P1394b Simulation Taskforce

February '99 Report

“Upstarts” Review Clause 11, Draft 0.15

“Bport” Review Clause 11, Draft 0.16

Improved Gap Detection

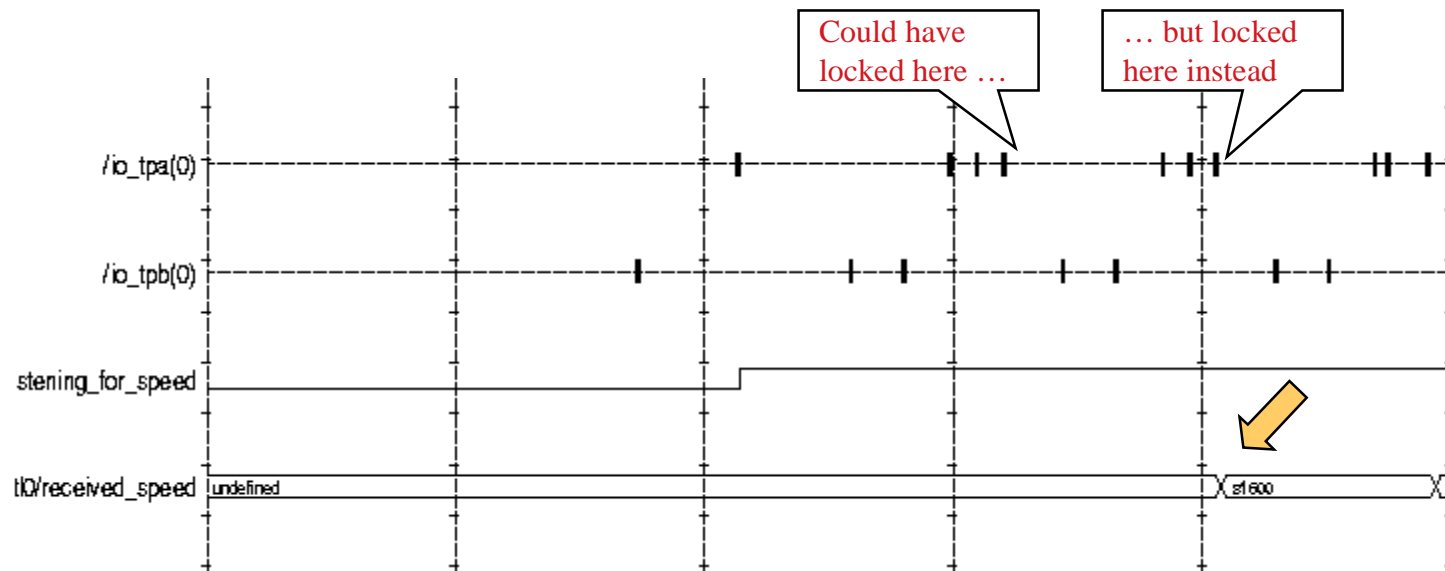
- Maximum idle run not part of a gap = 27 TONE_DURATIONS
- Maximum idle run between start bits = 63 TONE_DURATIONS
- Draft 0.15 code detected gap after 24 TONE_DURATIONS and expected a start bit within 59 TONE_DURATIONS from the last non-idle bit.
- Draft 0.16 detects a gap after 28 TONE_DURATIONS and expects a start bit within 64 TONE_DURATIONS after the last non-idle bit.

Delayed Speed Recognition

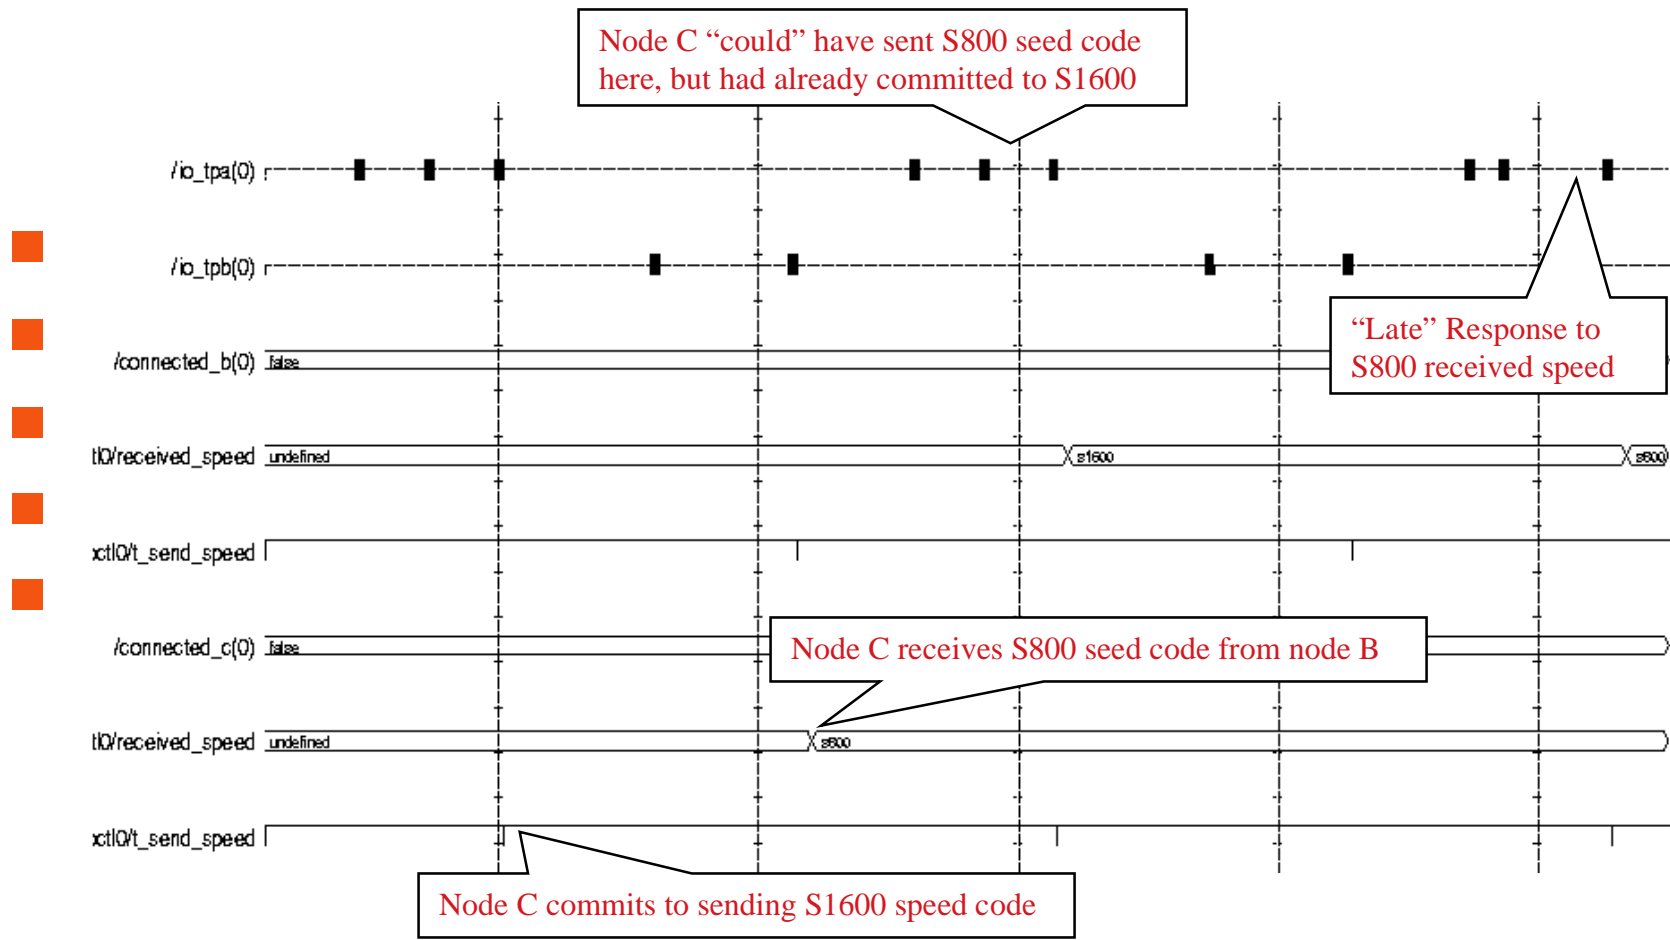
Extra Speed Signal

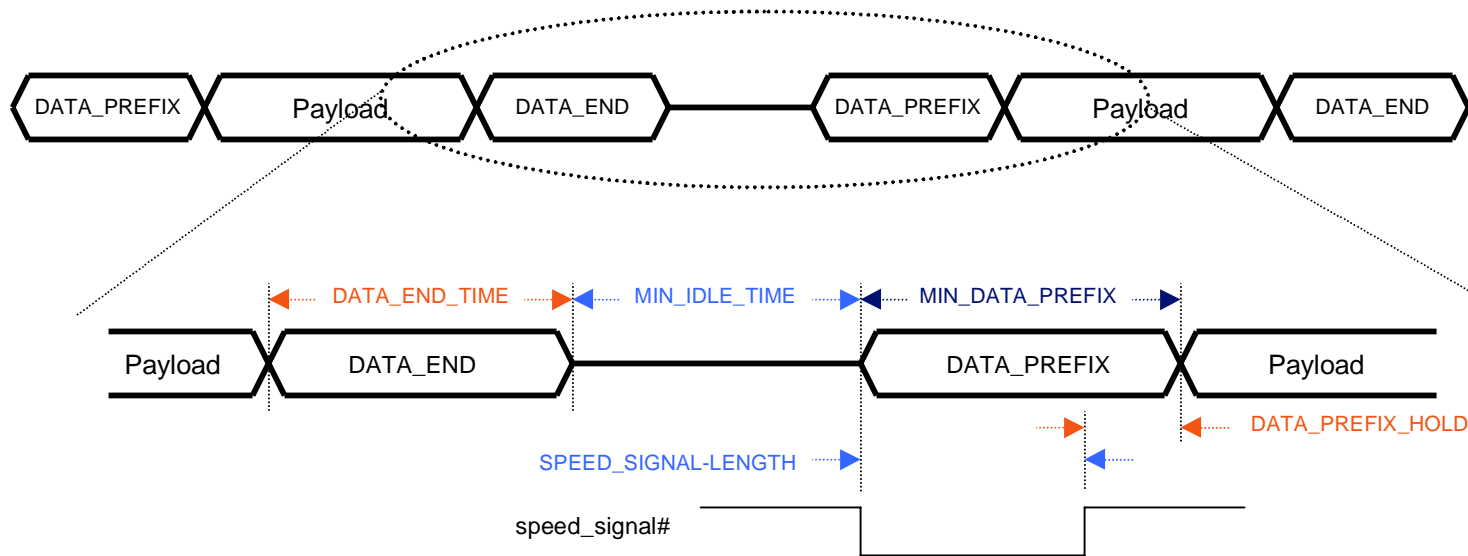
#	Reference	Description/Comment
1.		If DS port originates a packet with speed signal and DP coincidental with all min timings, how will beta mode PHY be able to repeat and have time to put a symbol of data prefix before the speed signal? Consider topology in which root P1394a PHY is attached to P1394b phy. As the root generates consecutive (non-concatenated) packets, there may not be any DATA_PREFIX before the speed signal. Seems like for each S200 packet, 40 ns of additional delay is inserted! Would it be better to distinguish between legacy and non-legacy packets in a different fashion?

“Sardine” Packets

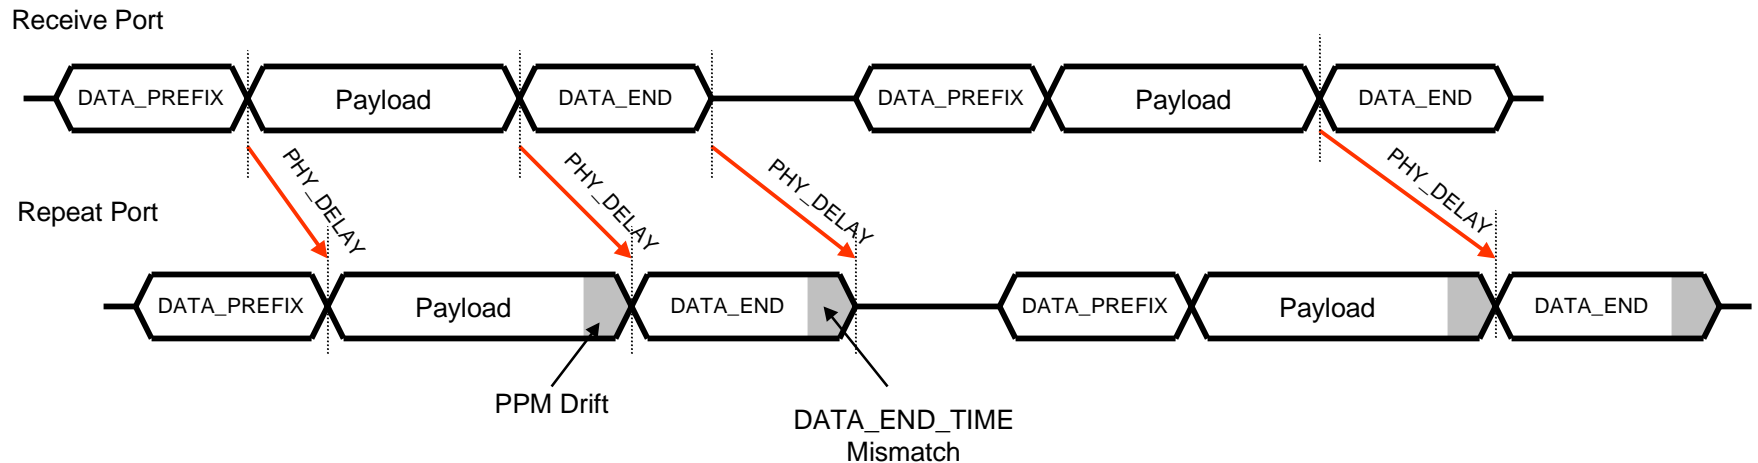
Minimum payload spacing allowed by P1394a:

$$\min(\text{DATA_END_TIME} + \text{MIN_IDLE_TIME} + \text{MIN_DATA_PREFIX})$$

Nothing is deletable!! Payload is not elastic and minimum timings are specified for originating and repeating ports.

Border Node Worsens Problem

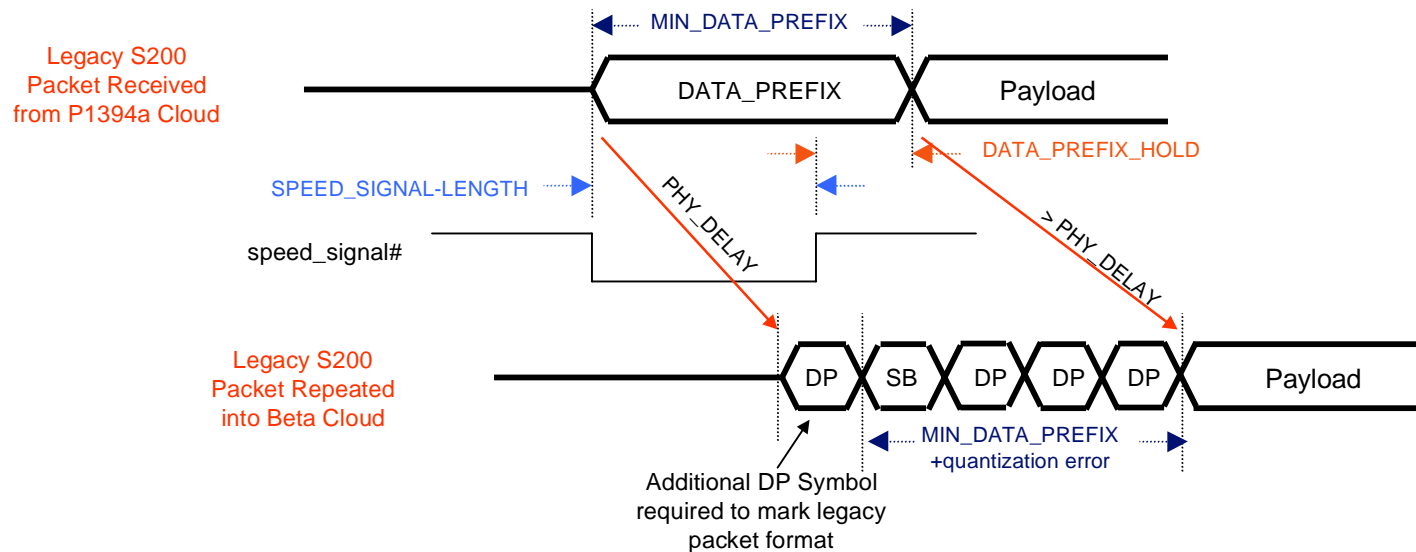
- Although speed signal and DATA_PREFIX can begin concurrently on a DS port, beta port signaling of a legacy packet requires an initial DP token
- The SB and subsequent DP tokens must consume at least MIN_DATA_PREFIX (140 ns). With 40 ns S200 symbol times, a 20 ns quantization error is inserted.

- Consider alternative way to distinguish legacy and beta-only packet formats (don't require insertion of extra symbol).
- Rules for meeting MIN_DATA_PREFIX on each individual legacy packet format must be relaxed to account for quantization error
 - As an average, timings must be met to bound FIFO depths at border nodes.
 - Instantaneously, allow +/- one symbol (?) to maintain average.
- All packets originated by a P1394b node should include an appropriate number of elastic symbols to allow for an unlimited number of minimally-spaced packets without violation of PHY_DELAY.

Interpretation of signal(EVENT)

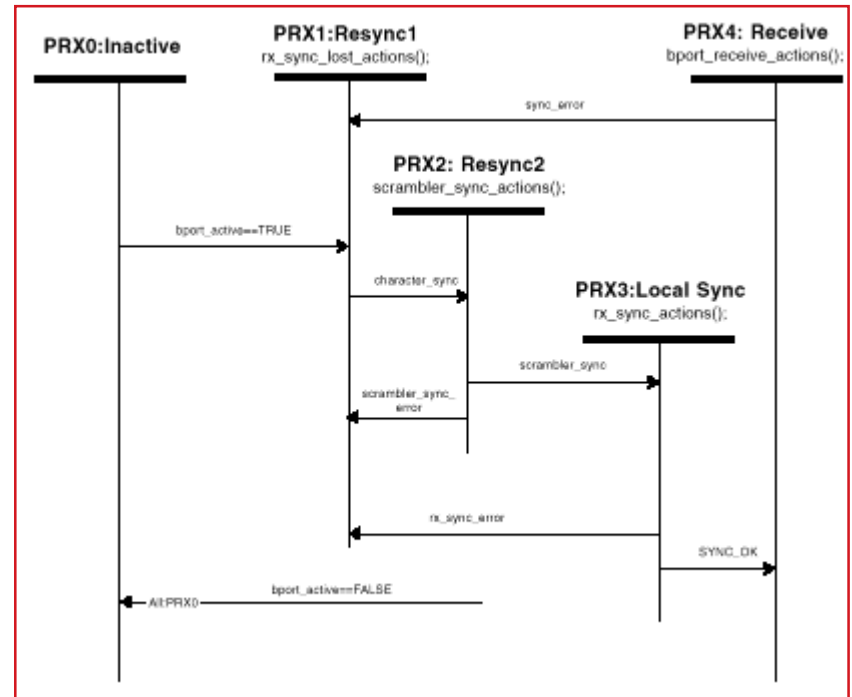
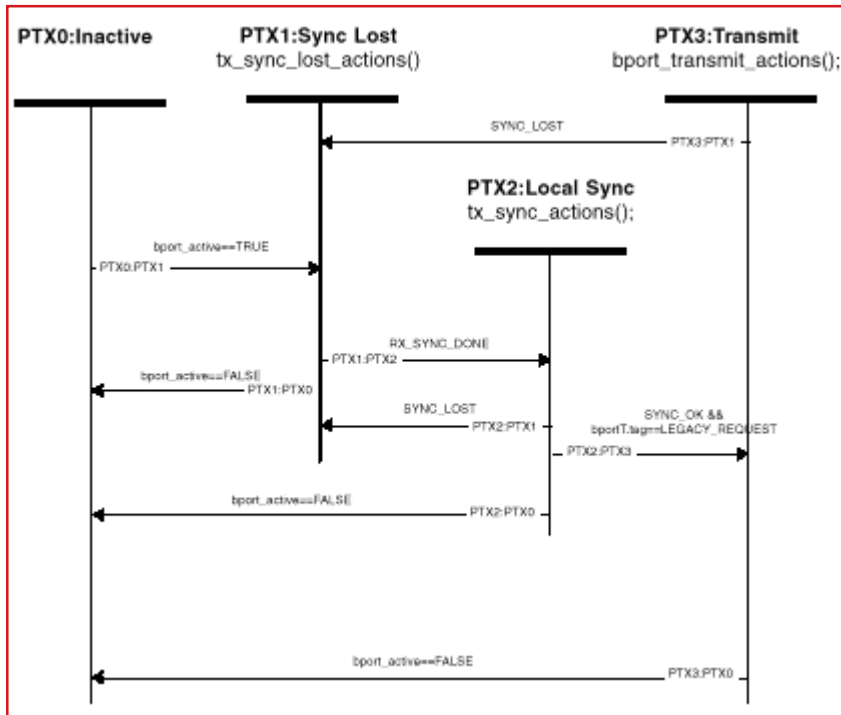
P1394a and P1394b both make use of the “invented” signal(EVENT) call to communicate between processes. Two plausible interpretations:

- signal(EVENT) causes EVENT to be set
- EVENT remains set until tested by a test_event or wait_event call
- Example from P1394a: test_event(SPEED_SIGNAL_RECEIVED) arguably determines if a speed signal was previously detected and latched

- signal(EVENT) causes a “one-shot” on EVENT
- Only processes waiting with wait_event() recognize the one-shot indication
- Example from P1394a/b: wait_event(PH_CLOCK.indication()) is intended to wait until the next rising edge of the bit clock.

- signal(EVENT) and wait(EVENT) follow the “one-shot” interpretation, allowing one process to suspend until the next indication signaled by a second process.
- For code which needs “semaphore” operation, shared variable should be used with explicit set and clear statements. This has the added benefit of allowing multiple process to test a given semaphore.
